ADDENDUM NO. 1

FAIRFIELD AND INDIAN VILLAGE ELEMENTARY SCHOOL SITE IMPROVEMENTS

Fort Wayne Community Schools (FWCS)

February 4, 2026

3. Plan Sheet E101 – Electrical Site Demolition Plan

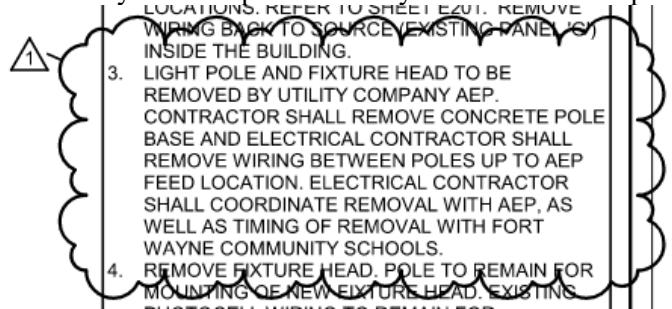
REVISED: Keynote 3 to provide clarity on demolition scope and timing on light pole.

4. Plan Sheet C201 – Dimensional Plan

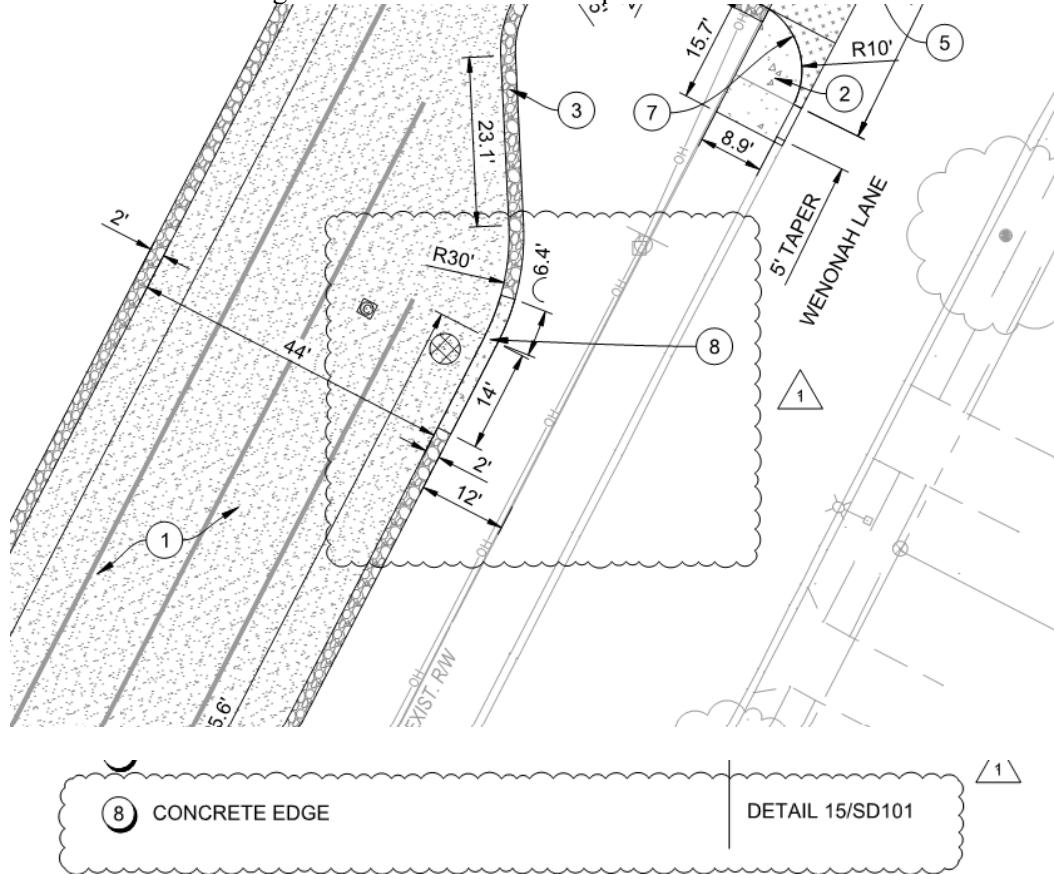
ADDED: Concrete edge for stormwater overflow path

5. Plan Sheet C301 – Grading Plan

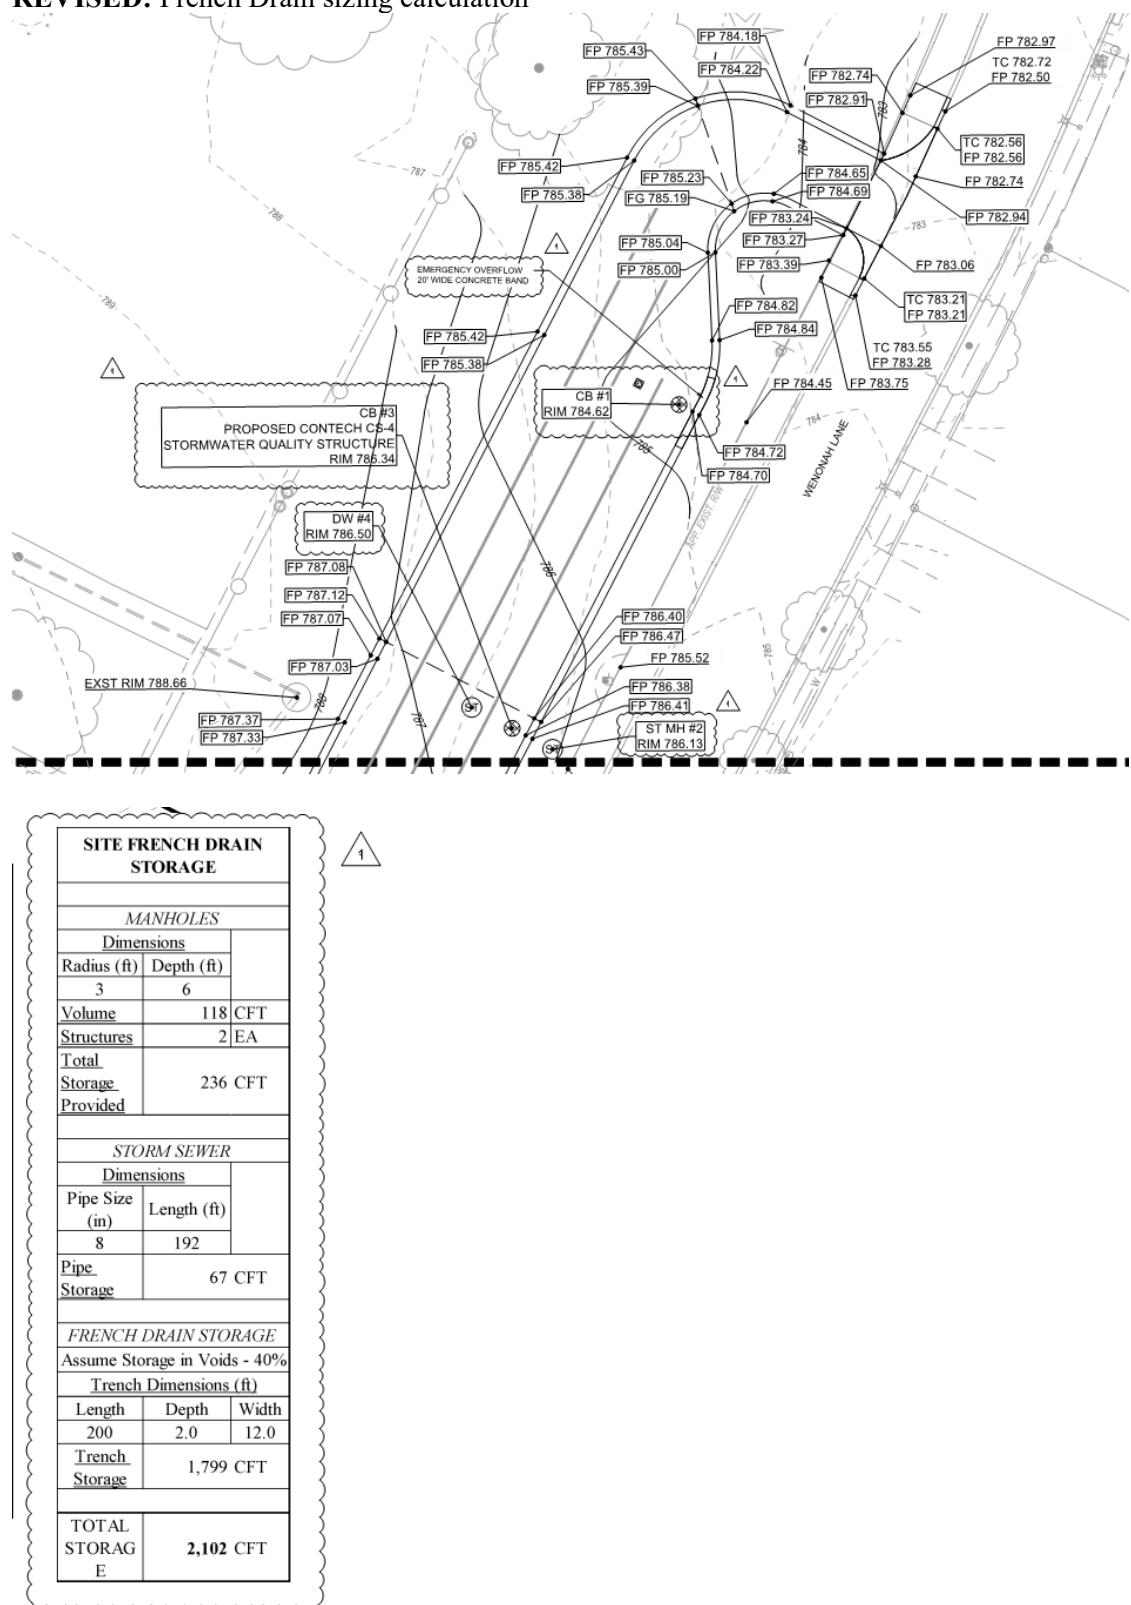
ADDED: Concrete edge for stormwater overflow path and rim elevation for additional MH

REVISED: French Drain sizing calculation

6. Plan Sheet C302– Grading Plan

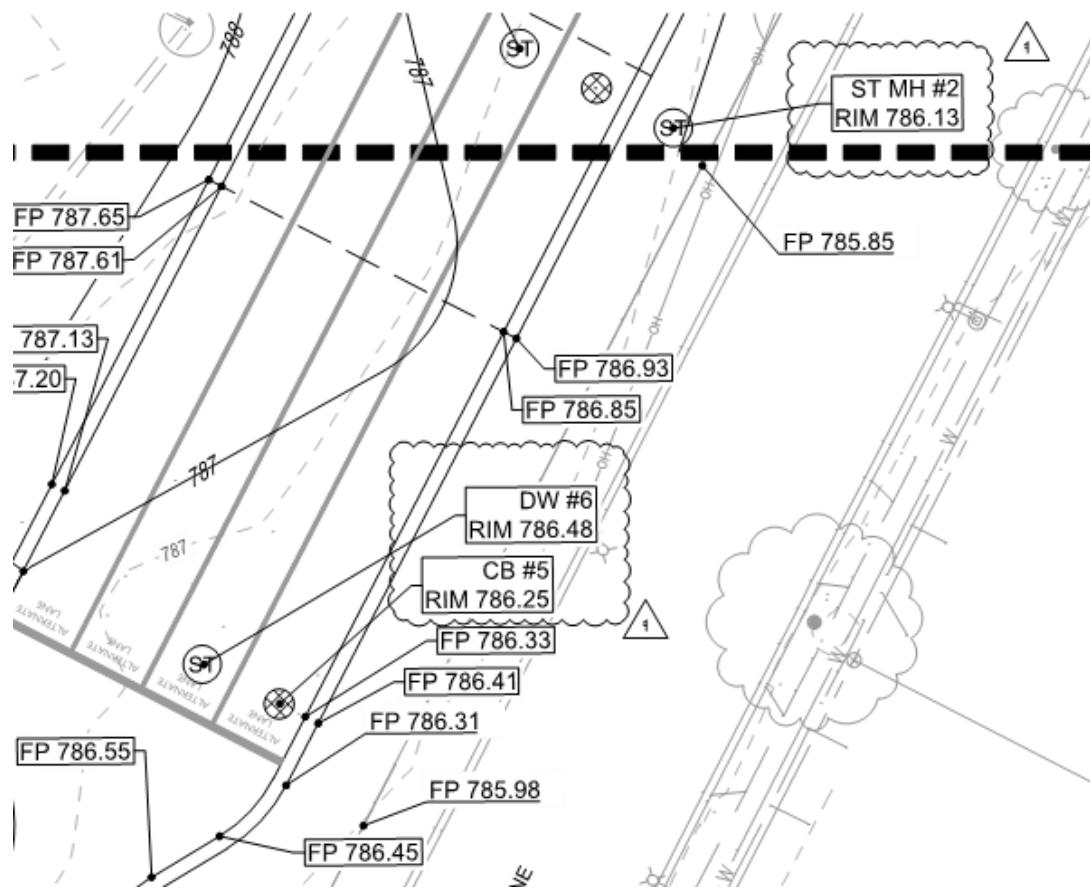
REVISED: Rim elevations for CB #5 and DW#6

PROPOSED STORM STRUCTURE INFORMATION	
CB #5 - 48"Ø CATCH BASIN	CASTING TYPE B
Rim Elev. = 786.25	
Inv. 781.29 - 8" PVC N	
DW #6 - 60"Ø PERFORATED DRYWELL	
CASTING TYPE A	
Rim Elev. = 786.48	
Inv. 780.23 - 8" HDPE PERFORATED N	
Inv. 780.13 - 12" PVC NW WITH ORIFICE PLATE	3 SD104
ST MH #7 - 48"X48" DOGHOUSE MANHOLE	
CASTING TYPE A	
Rim Elev. = 788.50	
Inv. 778.50± - 18" RCP SW	
Inv. 778.50± - 18" RCP NE	
Inv. 779.59 - 12" PVC SE

7. Plan Sheet C401– Utility Plan

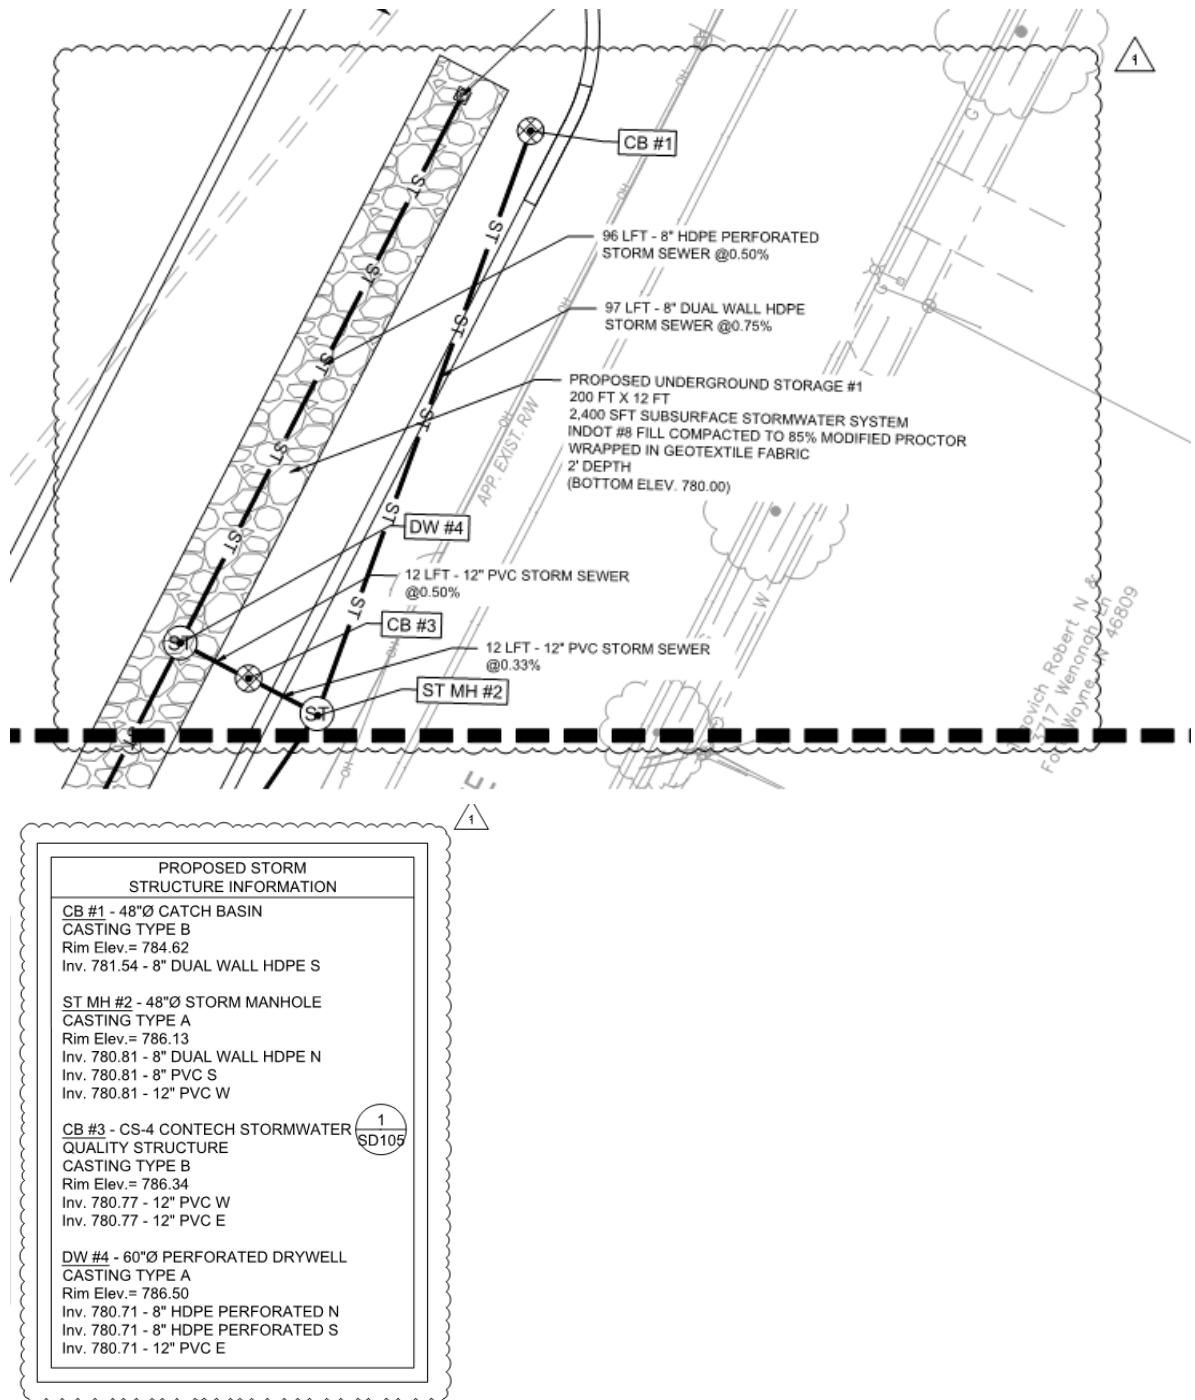
REVISED: Storm sewer configuration to account for proposed stormwater quality structure and structure data table.

8. Plan Sheet C402– Utility Plan

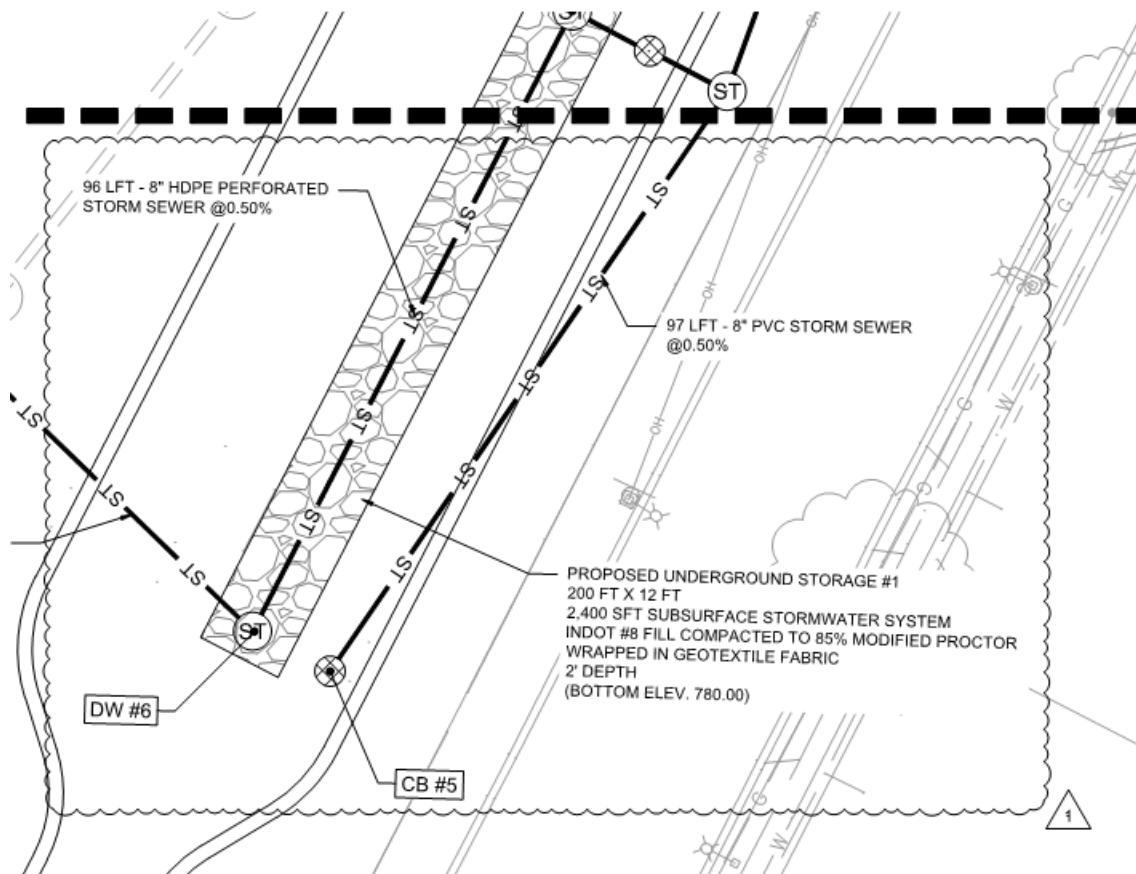
REVISED: Storm sewer configuration to account for proposed stormwater quality structure and structure data table.

10. Plan Sheet C602 – Landscape Plan

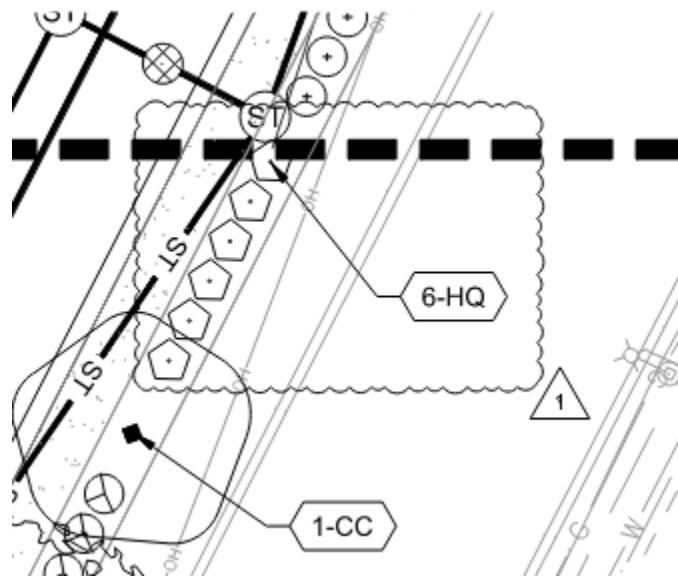
REVISED: Layout and quantity of Sikes Dwarf Hydrangea and remove on Easter Redbud tree on the east side of the drive near the matchline.

11. Plan Sheet SD101 – Site Details

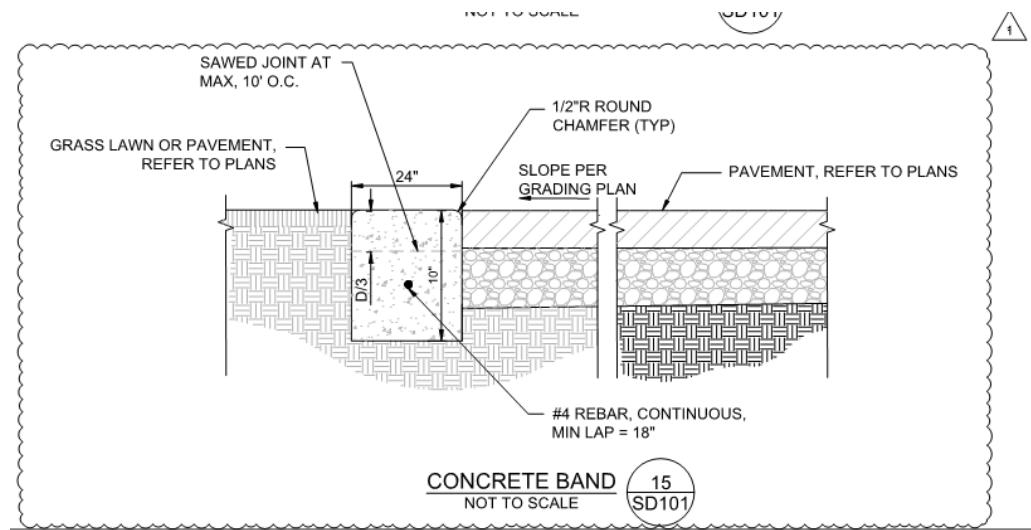
ADDED: Concrete band detail 15/SD101 for stormwater overflow

12. Plan Sheet SD102 – Site Details

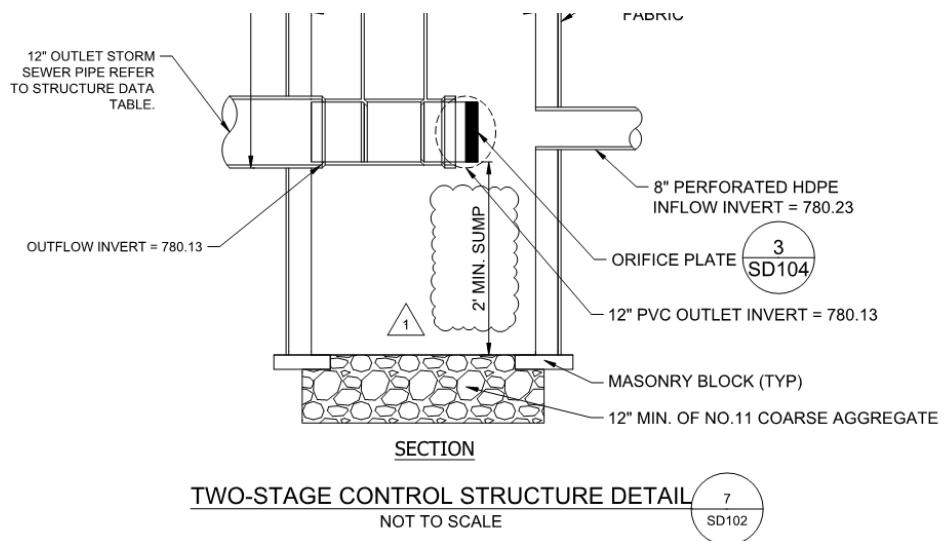
REVISED: Detail 7/SD102 to specify 2' sump

13. Plan Sheet SD103 – Site Details

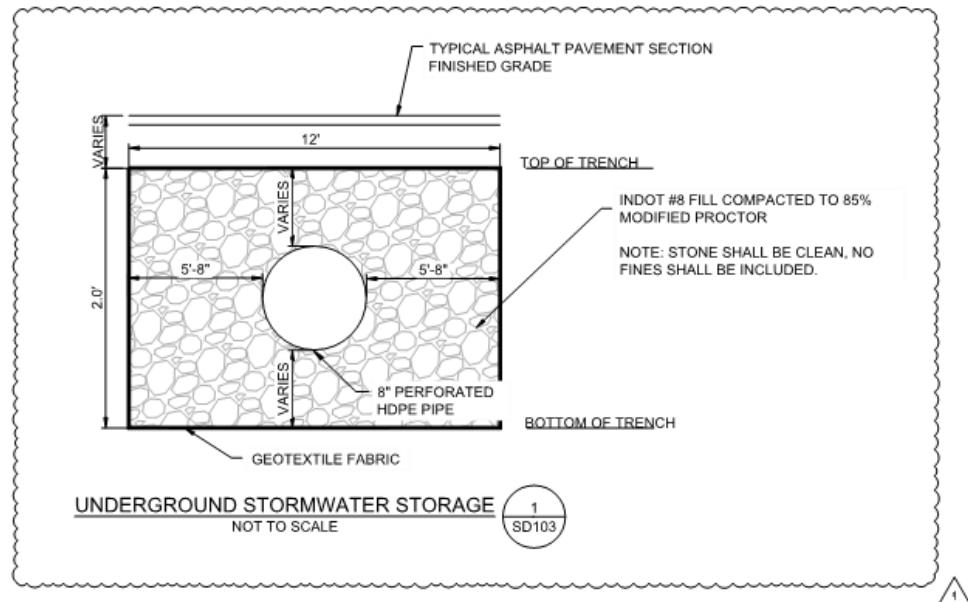
REVISED: Detail 1/SD103 to account for modified stormwater storage.

14. Plan Sheet SD104 – Site Details

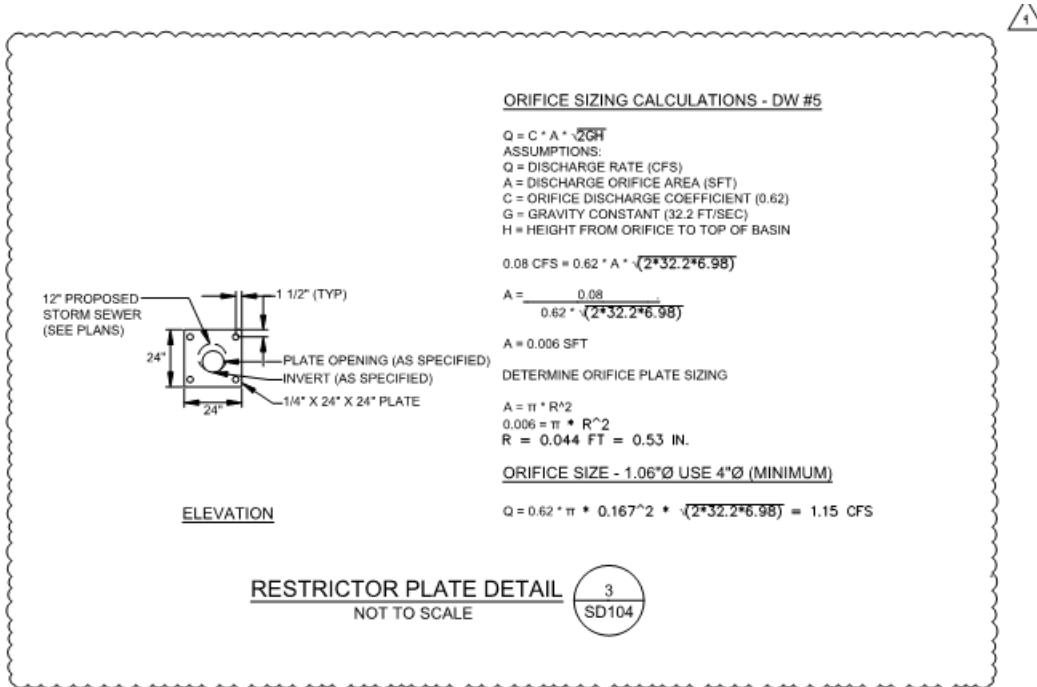
REVISED: Detail 3/SD104 to specify 4" orifice plate

15. Plan Sheet SD105 – Site Details

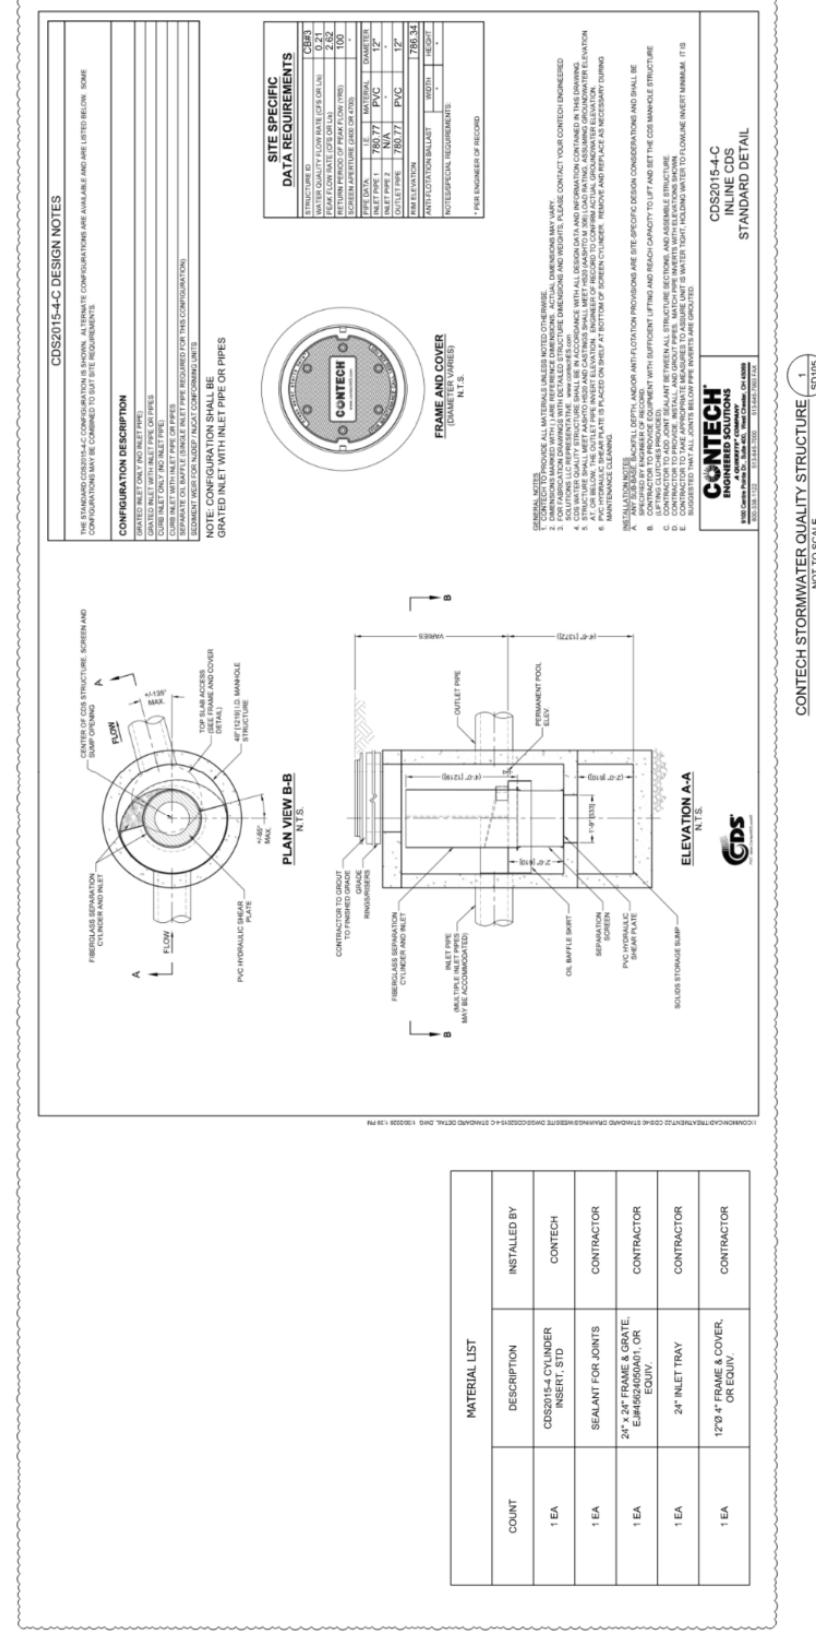
ADDED: Detail Stormwater Quality Structure
